ST/SG/AC.10/C.3/42/Add.1
16 July 2002

**REPORT OF THE SUB-COMMITTEE OF EXPERTS
ON ITS TWENTY-FIRST SESSION**

Addendum 1

Report of the Working Group on Additional Provisions for the Transport of Gases

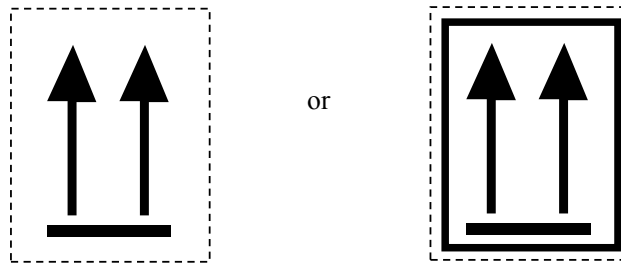
Add a new provision to Chapter 5.2 as follows:

5.2.2.1.13 The following orientation label shall be displayed on two opposite sides of cryogenic receptacles intended for the transport of refrigerated liquefied gases. They shall be rectangular, of standard format 74 x 105 mm (A7). If the size of the package so requires, the dimensions of the labels may be changed, provided that they remain clearly visible.

Two black or red arrows on white
or suitable contrasting background
